RBKC MOE - P1
Comments in blue by RBKC Building control

STUDIO E LLP		
Palace Wharf, Rainville Road, London W8 9AH, Tel: 020 7385 7128 Fax: 020 7381 4995		
GRENfell TOWER REGENERATION PROJECT		
PROJECT		
FIRE ACCESS PLAN		
DRAWING		
1:100@A1	24/10/13	
SCALE	DATE	
1279 (08) 100 00		BS
DWG. NO.	REV. NO.	CHECKED

1 MEZZANINE
1:100

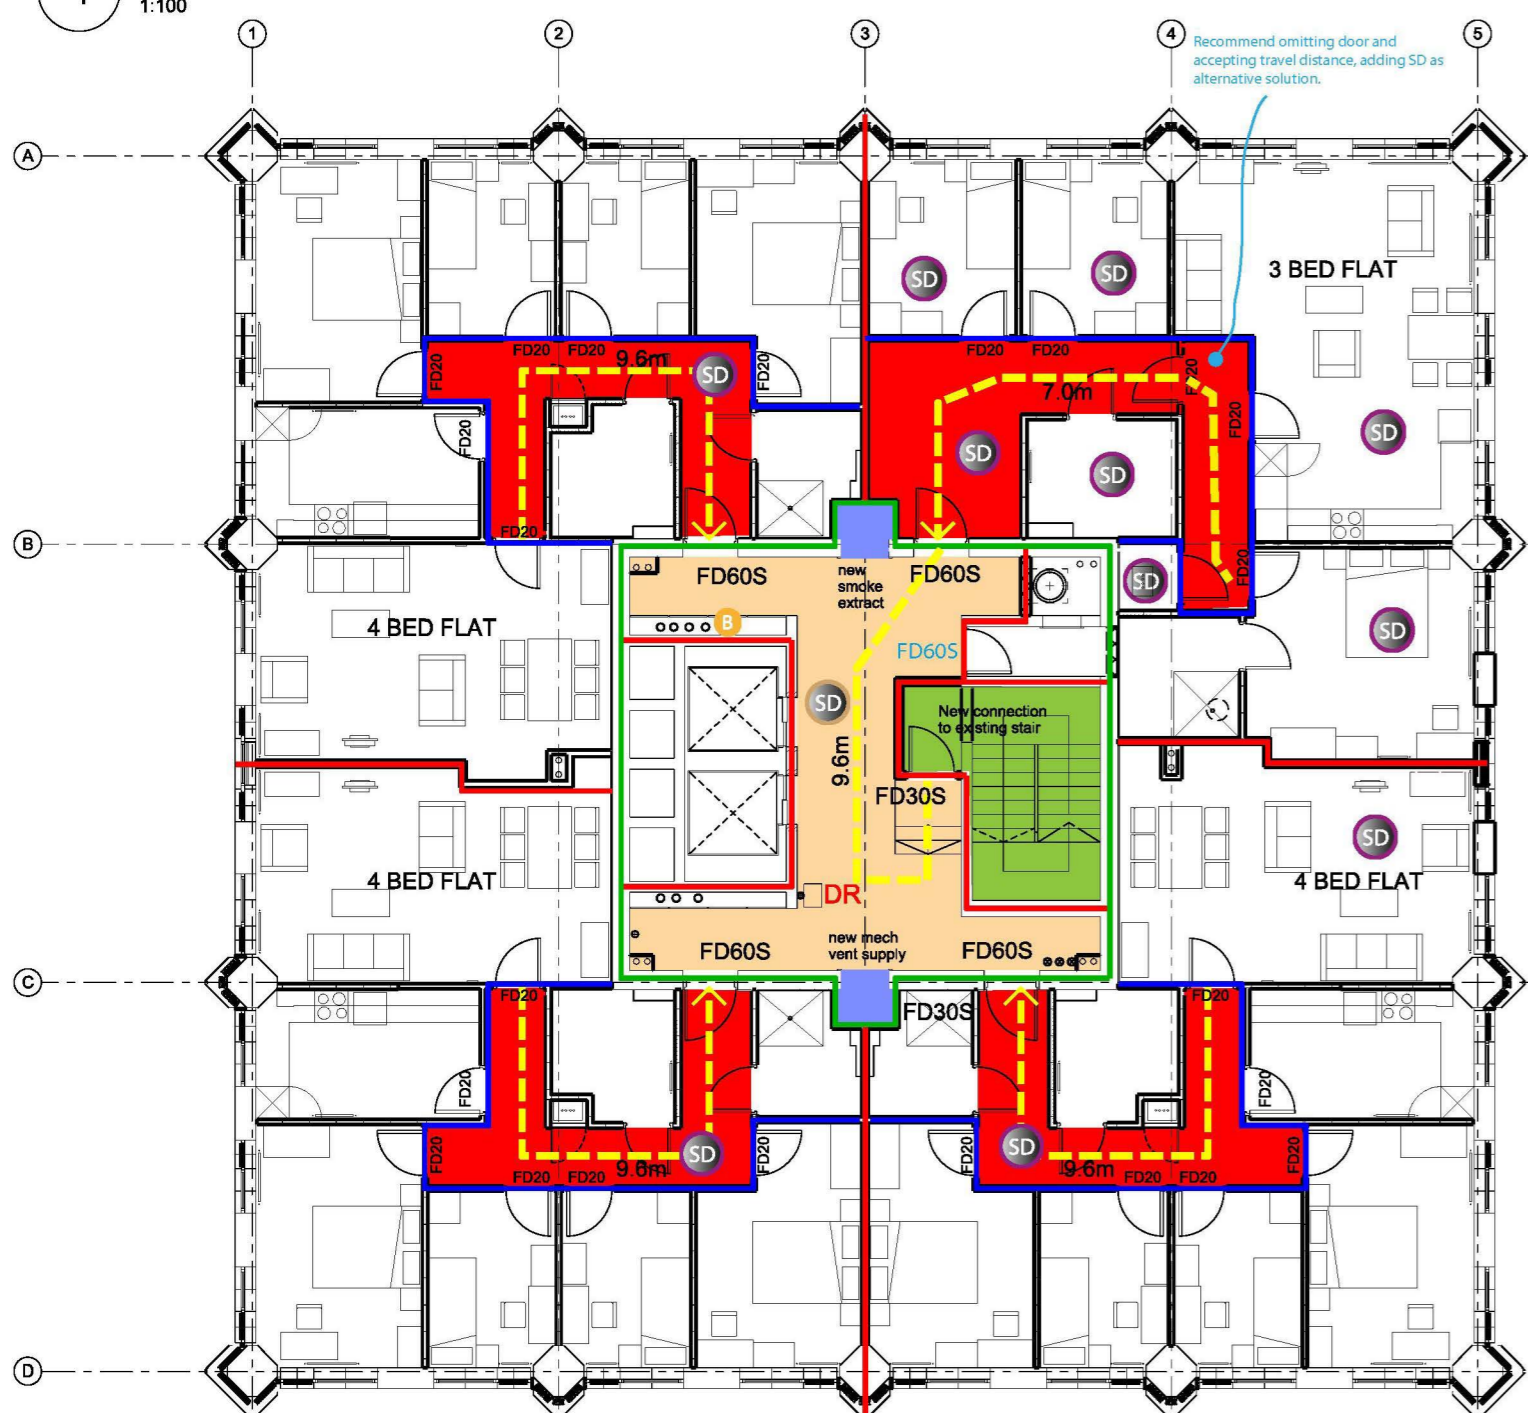
This is a room. Venting the room would not provide the same level of protection as venting a lobby thereto. In this case an unvented lobby separation to the residential escape is considered appropriate.

No details of existing extract / supply rates are given therefore no consideration could be given of adverse affect on existing system. If system designers wish to redesign the system without consideration of adverse affect, justification for the proposed extract rate needs to be submitted, including performance modelling.

2 WALKWAY LEVEL
1:100

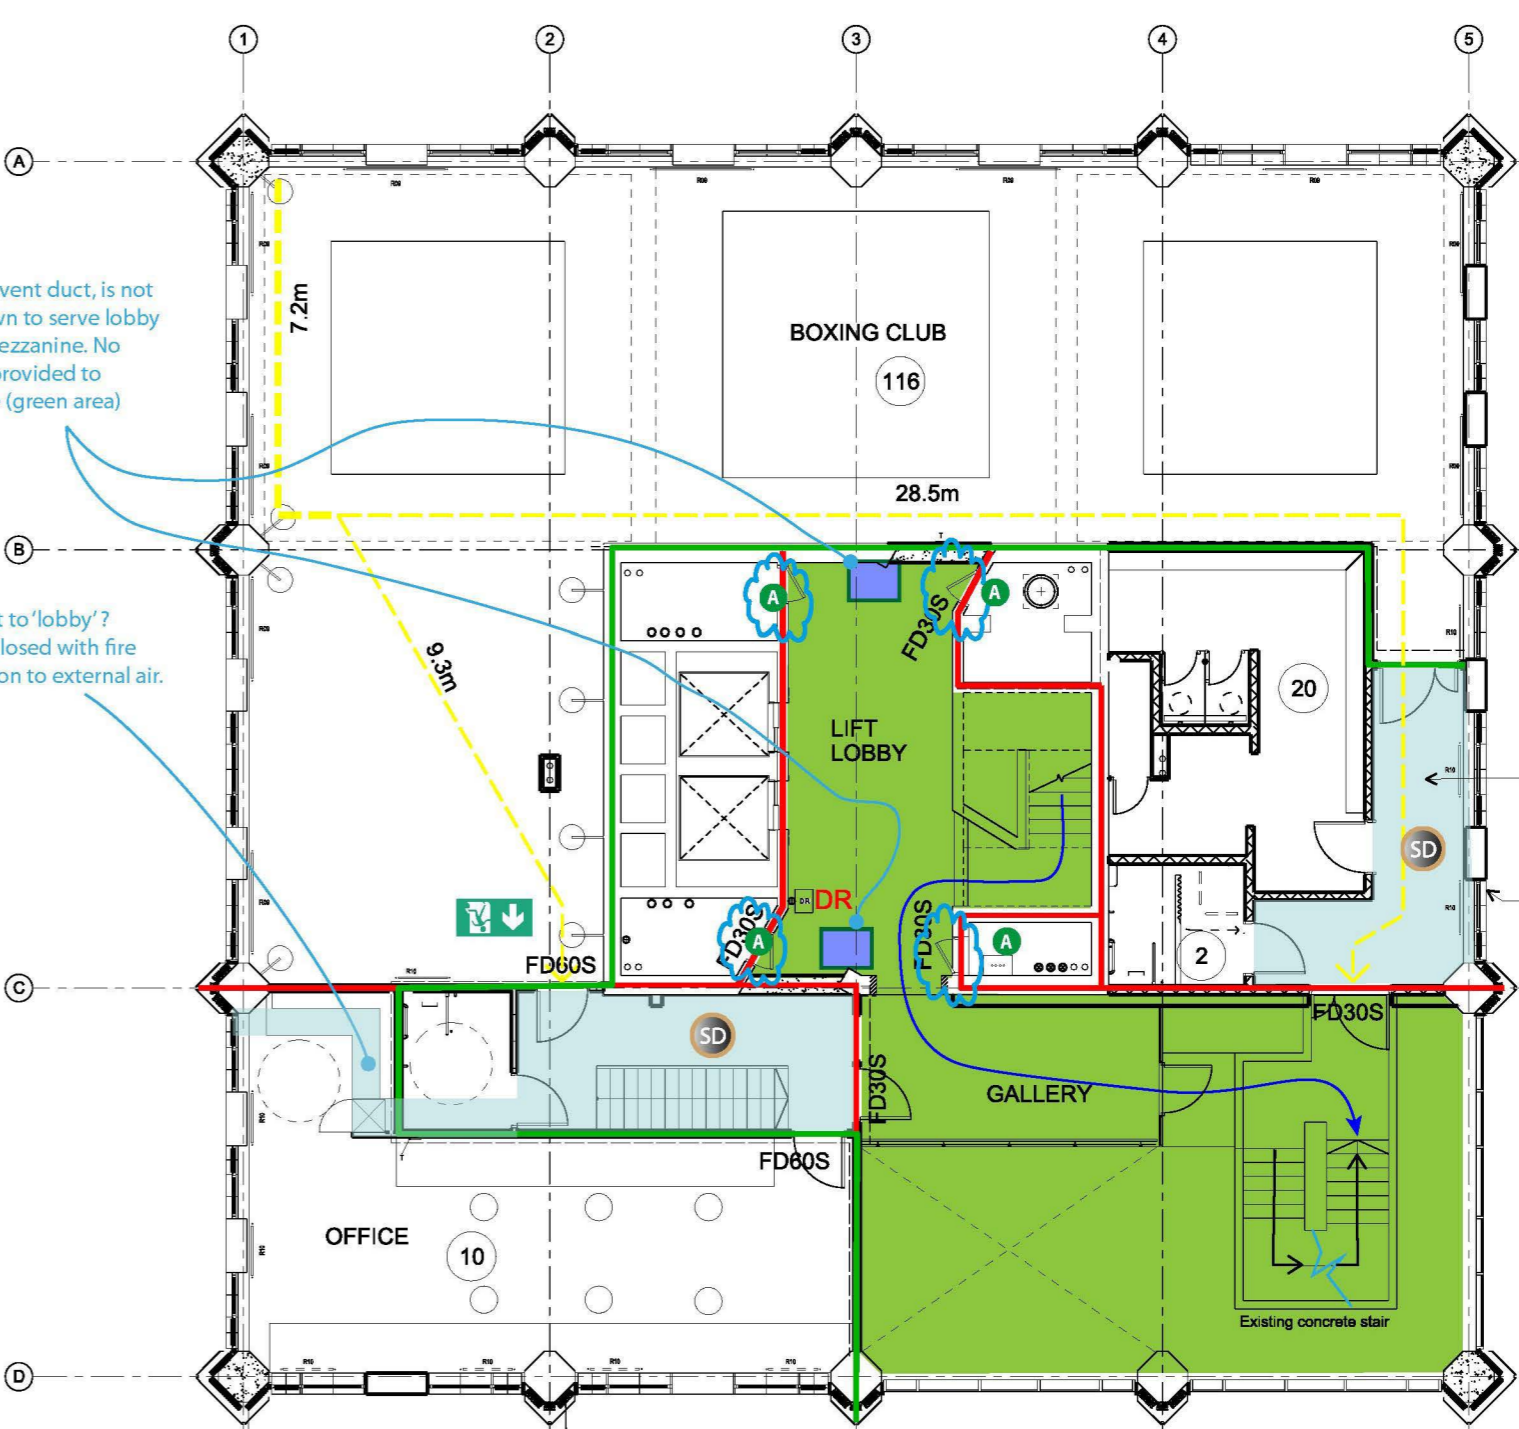
Access should not be provided to services from the single stairway. (Hot and cold water/dry riser services are acceptable in metal pipes with suitable fire stopping). (Note in the existing building these risers were in the lobby). Can these access panels be sealed at this level?
